CHAPTER 1 [CE]

SCOPE AND ADMINISTRATION

C101.1 Title. This code shall be known as the *Washington State Energy Code*, and shall be cited as such. It is referred to herein as "this code."

FIGURE C405.2.45.2(1)
SIDELIT DAYLIGHT ZONE ADJACENT TO FENESTRATION IN A WALL

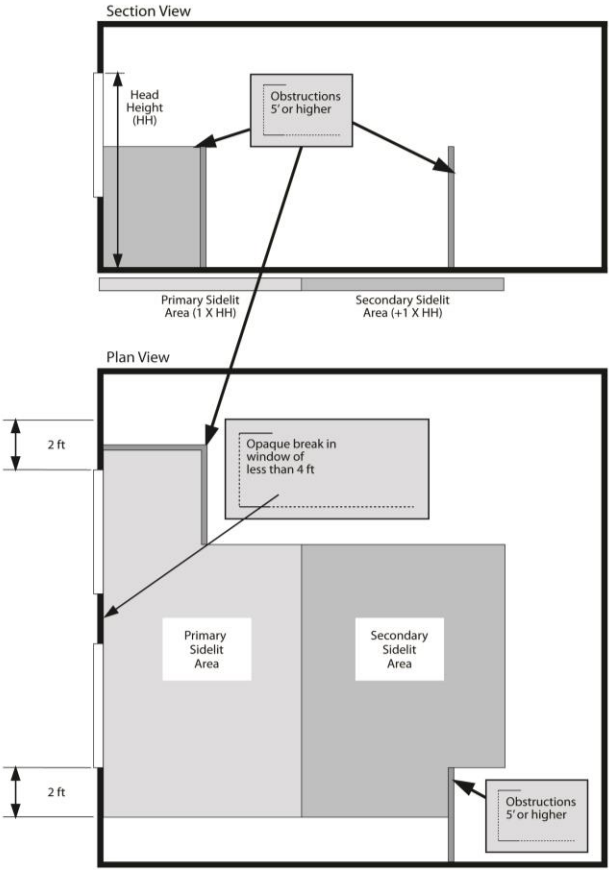
Commented [BK(188]: CE193-19 moves this section into the sidelit daylight zone rather than the toplit daylight zone.

FIGURE ~~C405.2.4.3(4)~~C405.2.5.4
~~TOPLIT ZONE UNDER ATRIUM FENESTRATION~~ DAYLIGHT ZONES AT A MULTISTORY ATRIUM

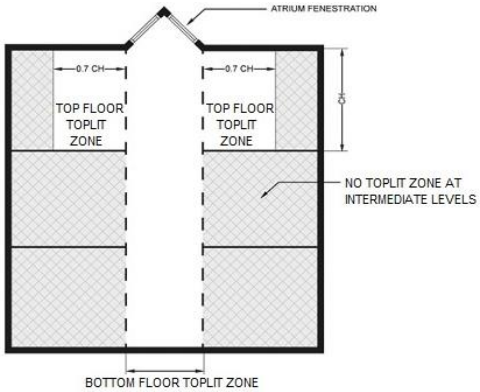
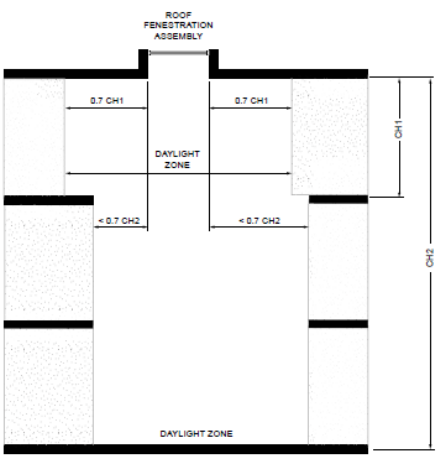
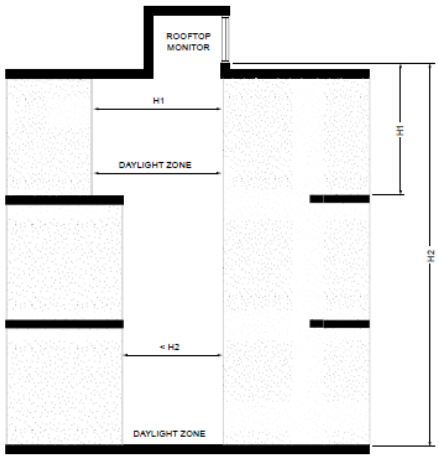
Commented [BK(189]: CE196-19

C405.2.5.4 Atriums. Daylight zones at atrium spaces shall be established at the top floor surrounding the atrium and at the floor of the atrium space, and not on intermediate floors, as indicated in Figure C405.2.5.4
